New Albany Planning Commission Agenda
Monday, December 18, 2023 7:00 p.m.

VAR-116-2023 Variance

Variance to the Woodhaven zoning text to allow two 8-foot wide single bay garage doors where the text requires a minimum width of 9-feet at 7275 Steeplechase Lane N (PID: 222-005343).

New Albany Planning Commission
DRAFT Meeting Minutes
Monday, December 4, 2023 7:00 p.m.

LEISURE PATH DETAIL
NO SCALE

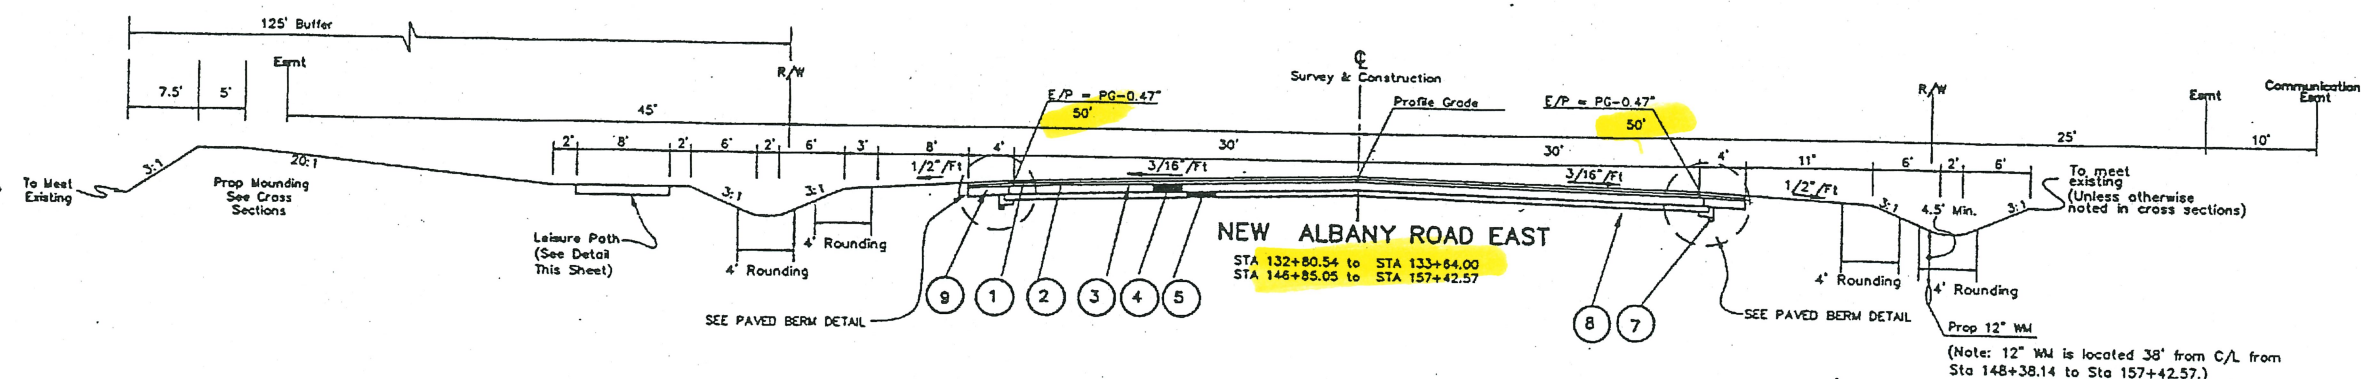
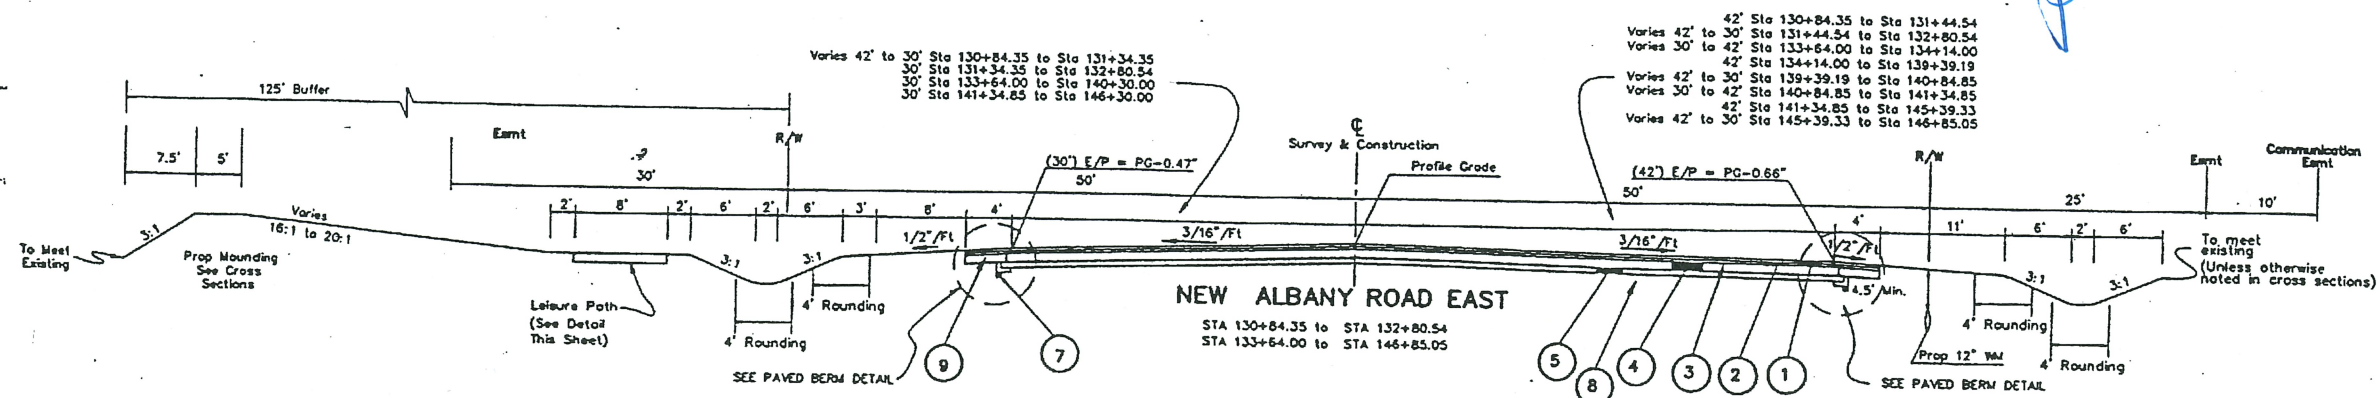
LN = 50' from Q
ALREADY provided

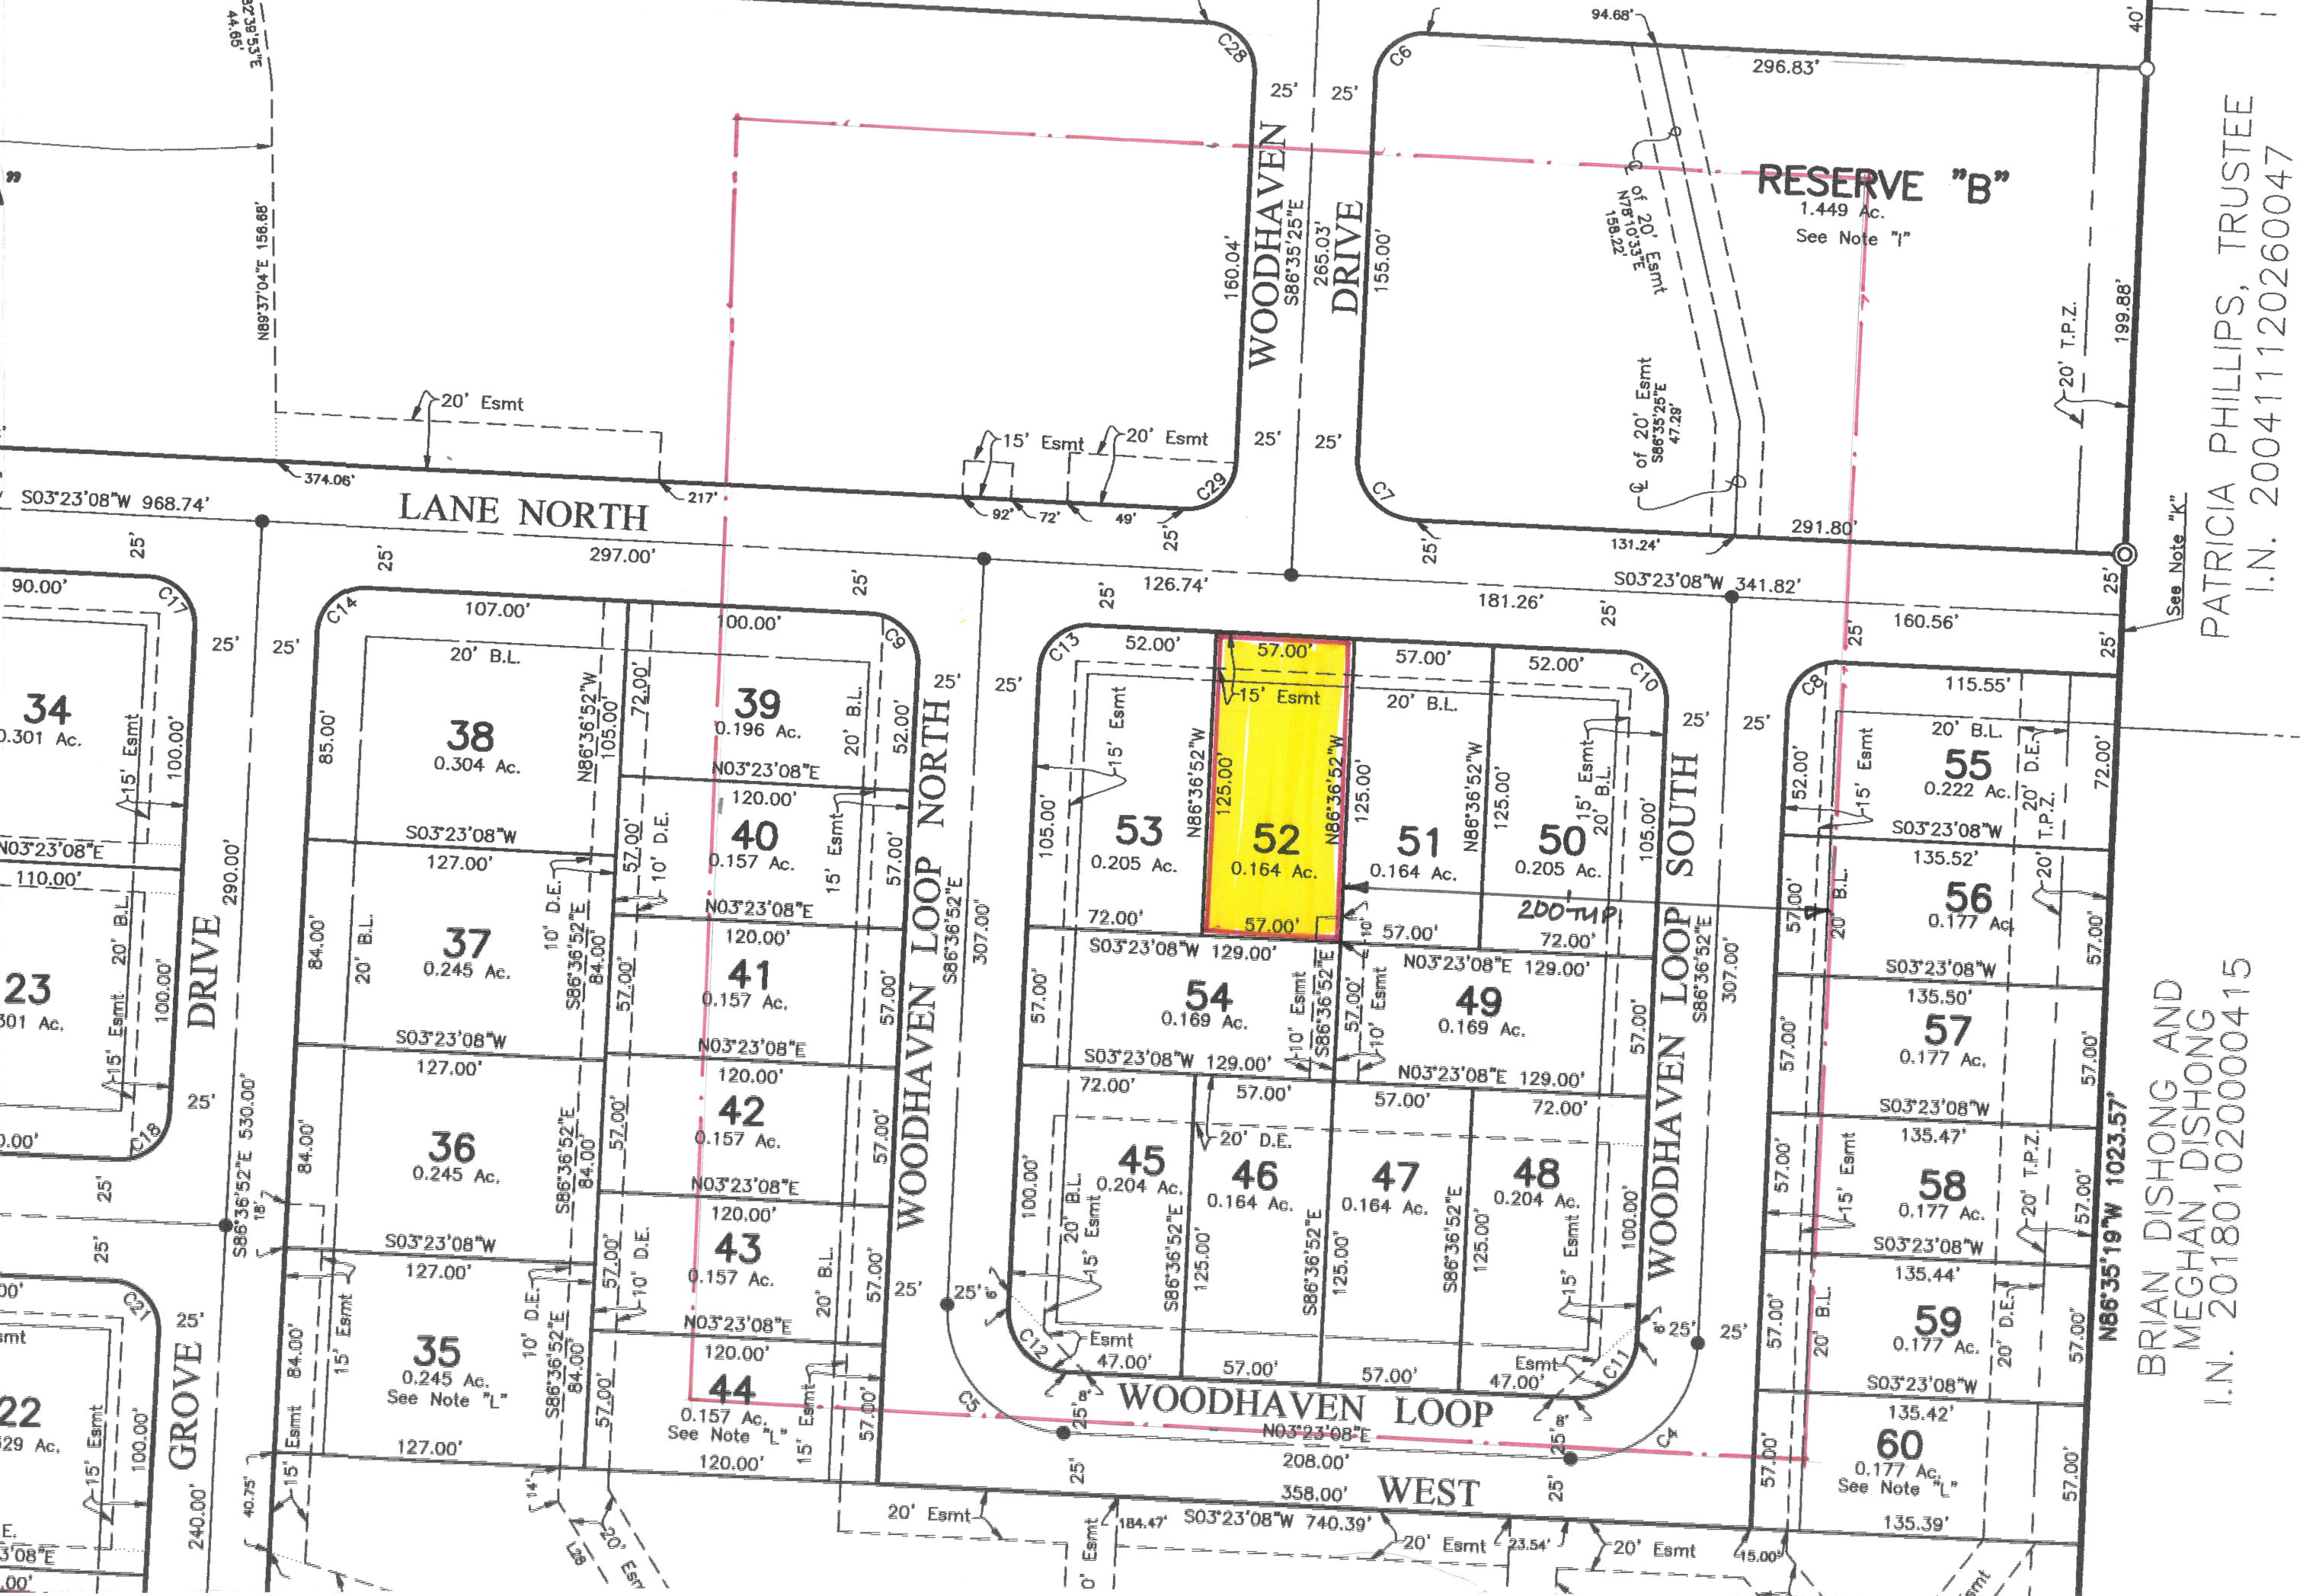
Both The Applicant & The Zoning Staff missed the Maximum 10' wide Garage Door Requirement in the Development Text. Granting The Variance Allowing 8'-0" wide Doors In Lieu of the required minimum 9' Wide Doors will allow this House to more Closely match the intent of the Development Text.
